2. CASE 22.022, 59 PARADE STREET, House, c1870 (ARMORY)

Project: Two Family Residence
Address: 59 Parade Street, Providence, RI 02909
Date: 12 February 2022
Revised – 17 March 2022
Re: Application Information

NARRATIVE – Scope of Work

1 SOUTH ELEVATION - WILLOW STREET
A2.1 1/4" = 1'-0"

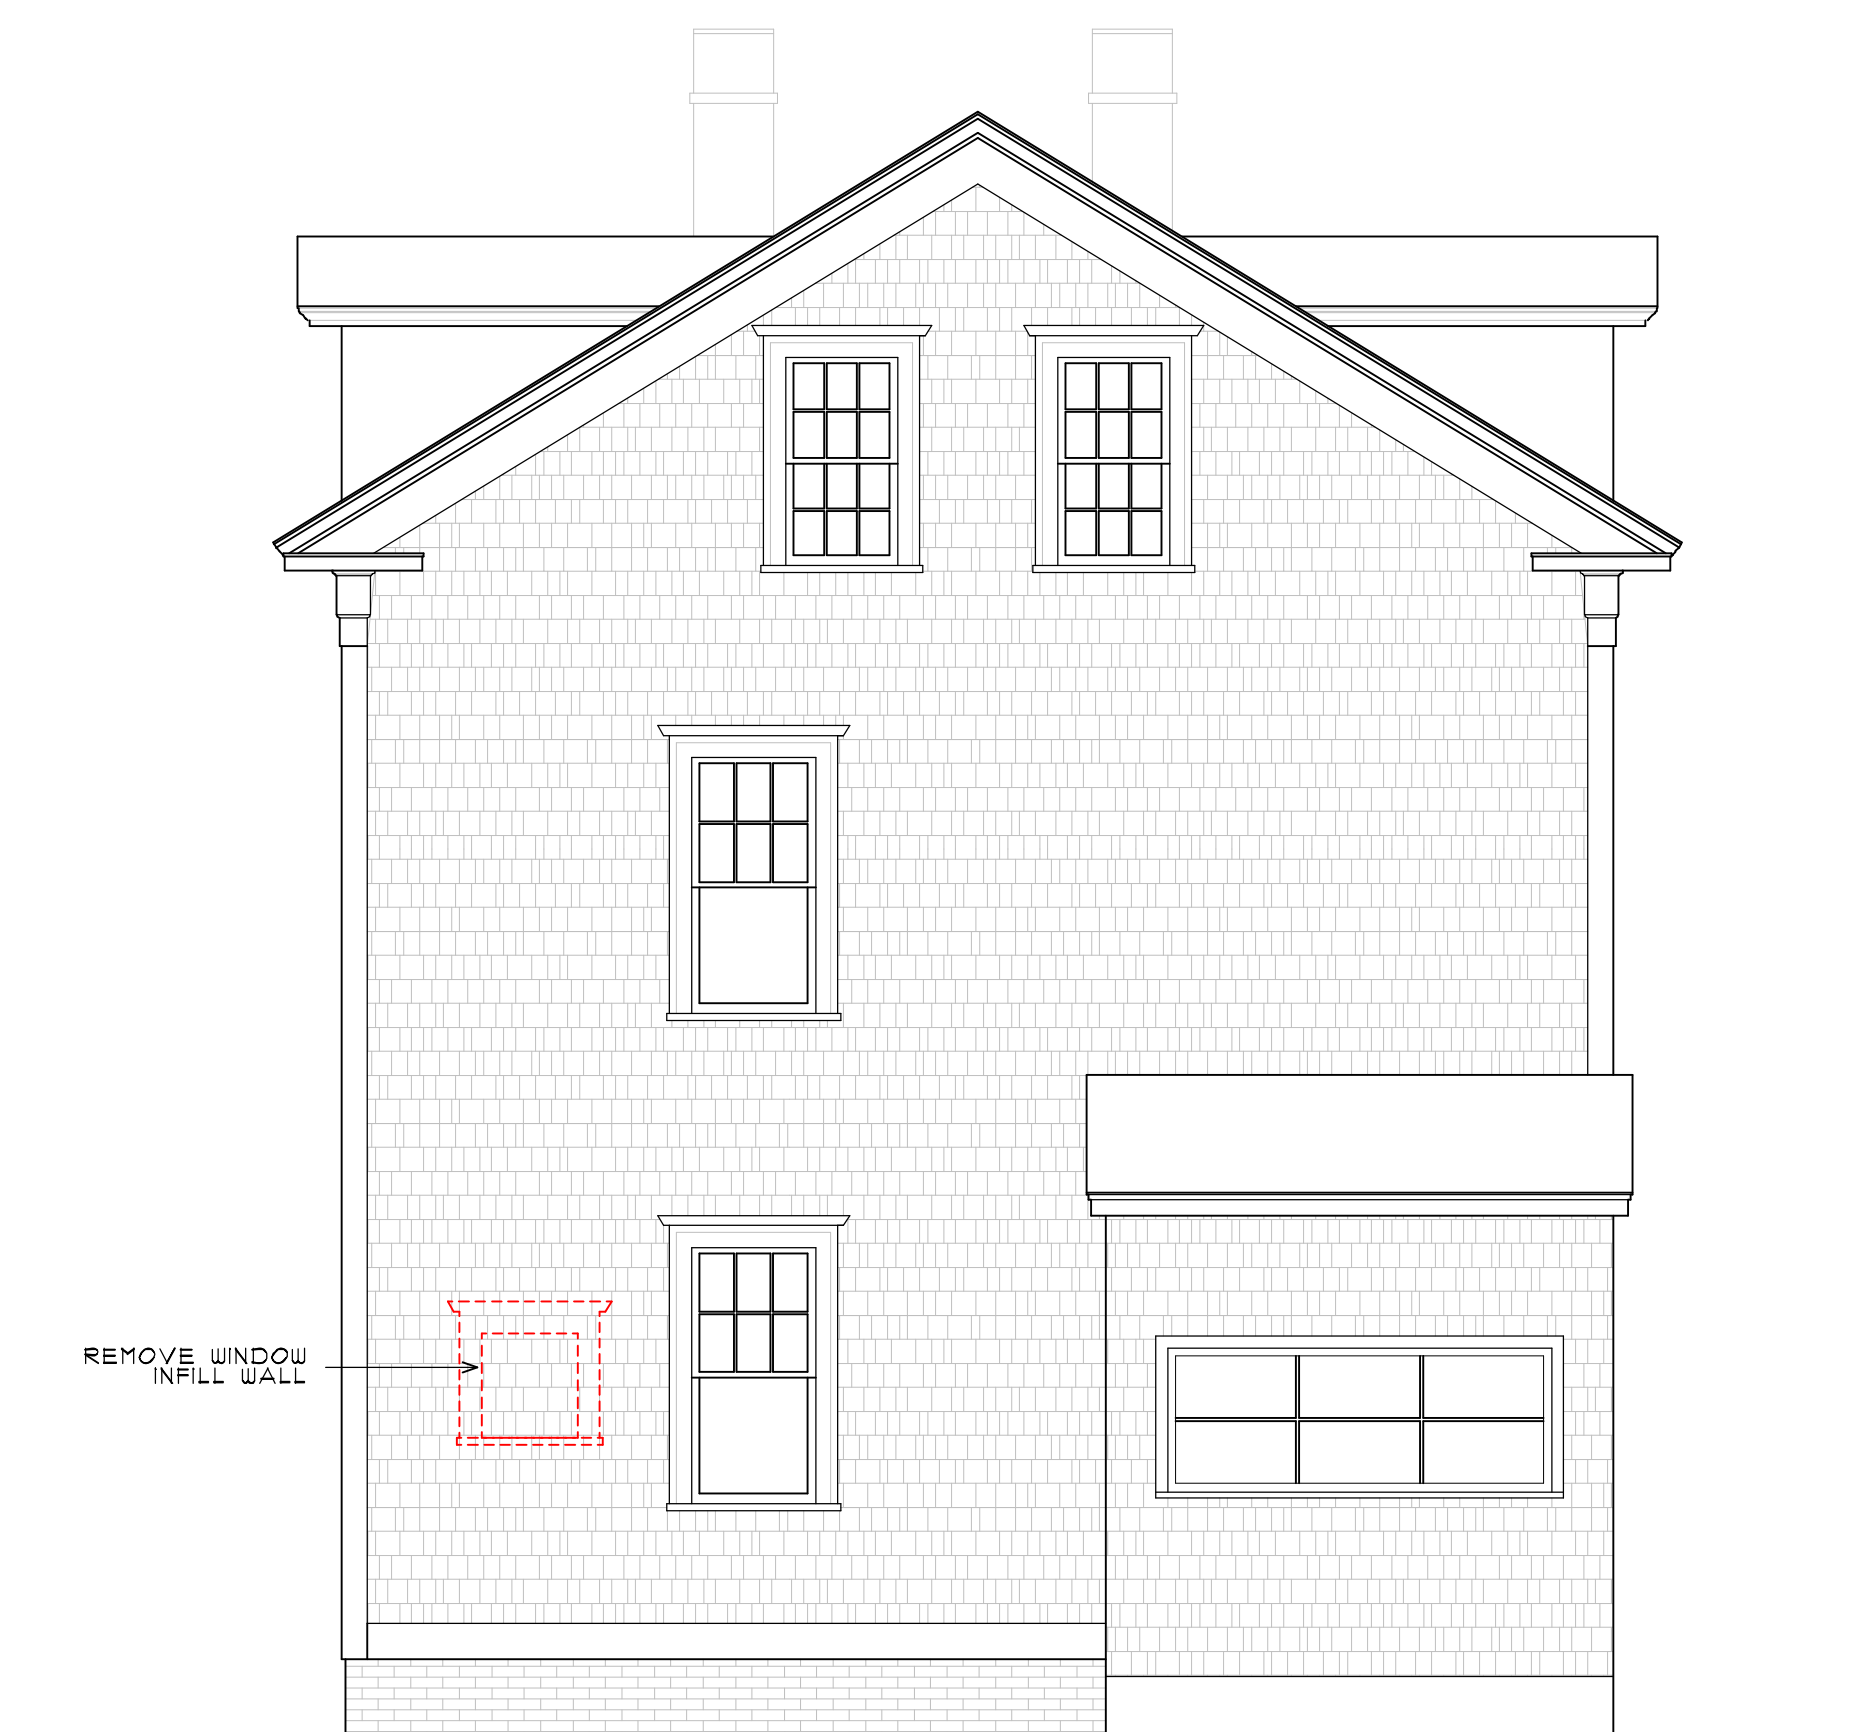
- At the 2/28 meeting the item was continued. At that meeting the Commission had concerns about the proposed screening-in of the porch: how would the details be handled? Would it be a three-season porch, with the screens removed in the winter? Staff noted that it was common for porches to be screened-in as a three-season element. Also concerns about the dormers. Agreement that rearranging the door and windows on the second floor was acceptable. The dormers have been removed from the proposal and skylights have been proposed. The majority of the proposed modifications will be visible from the public rights-of-way; and,
- Revised plans and photos have been submitted.

- a) 59 Parade Street is a structure of historical and architectural significance that contributes to the significance of the Armory local historic district having been recognized as a contributing structure to the Broadway/Armory National Register Historic District;
- b) The application for Major Alterations is considered complete; and,
- c) The work as proposed is in accord with PHDC Standards 8 & 9 as follows: 8) the work will be done so that it does not destroy the historic character of the property or the district; and, 9) Whenever possible... alterations to structures shall be done in such a manner that if removed in the future, the essential form and integrity of the structure and the site will be unimpaired.

Staff recommends a motion be made stating that: The application is considered complete. 59 Parade Street is a structure of historical and architectural significance that contributes to the significance of the Armory local historic district having been recognized as a contributing structure to the Broadway/Armory National Register Historic District. The Commission grants Final Approval of the proposal as submitted having determined that the proposed alterations are appropriate as the proposed alterations are architecturally and historically compatible with the property and district having an appropriate size, scale and form that will not have an adverse effect on the property or district and is reversible (Standards 8 & 9), citing and agreeing to the recommendations in the staff report, with staff to review any additional required details.
